# Access Compliance Report

## Public Rights-of-Way

Intersection ID: 44909	Main Street: PALUSTRIS_CT	Cross Street: OAKBURN_DR	Location: NE
ADA ID: EF4F225D78A9	Ramp Type: PerpDiag	Initial Pass/Fail: Fail	Overall Compliance: No
		Severity Score: 10

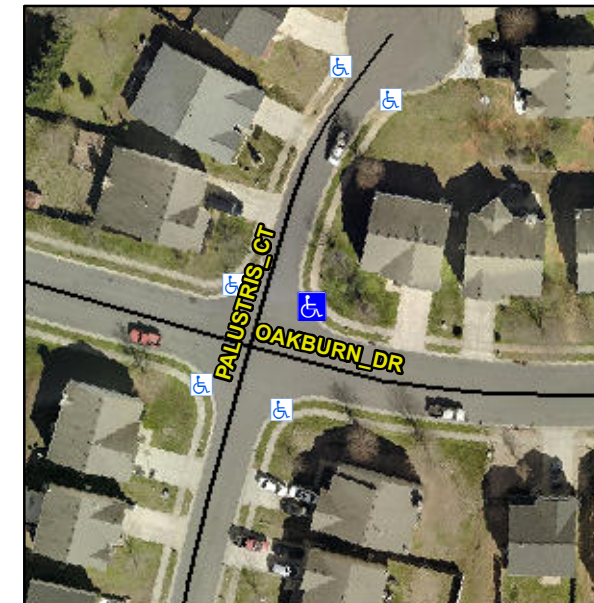
**Not Found, R304.5.1, R304.5.3**

Compliance	Description	Data	Compliance	Description	Data
N/A	Ramp Length (in)	48.0	Yes	Ramp Slope (%)	7.1
No	Ramp Width (in)	42.5	No	Ramp XSlope (%)	2.5
N/A	Flare Type LT	N/A	N/A	Flare Type RT	N/A
N/A	Flare Slope LT (%)	N/A	N/A	Flare Slope RT (%)	N/A
N/A	Flare Traversable LT?	N/A	N/A	Flare Traversable RT?	N/A
N/A	Landing Length (in)	N/A	N/A	DWS Provided?	N/A
N/A	Landing Width (in)	N/A	N/A	DWS Contrast?	N/A
N/A	Landing Slope (%)	N/A	N/A	DWS Length (in)	N/A
N/A	Landing X Slope (%)	N/A	N/A	DWS Full Width?	N/A
N/A	Landing Curb? (Y/N)	N/A	N/A	DWS Offset (in)	N/A
N/A	Shared Landing?	N/A			
N/A	Gutter Ponding?	N/A	N/A	Gutter Slope (%)	N/A
N/A	Gutter Lip Ht (in)	N/A	N/A	Gutter X Slope (%)	N/A
N/A	Painted X Walk1?	No	N/A	Painted X Walk2?	No
	X Walk 1 Direction	To NW		X Walk 2 Direction	To SW
N/A	X Walk 1 Width (in)	N/A	N/A	X Walk 2 Width (in)	N/A
	X Walk 1 Slope (%)	3.3		X Walk 2 Slope (%)	1.0
	X Walk 1 X Slope (%)	2.4		X Walk 2 X Slope (%)	3.4

**Remove & Replace Curb Ramp With Two New Directional Ramps or Equivalent.**
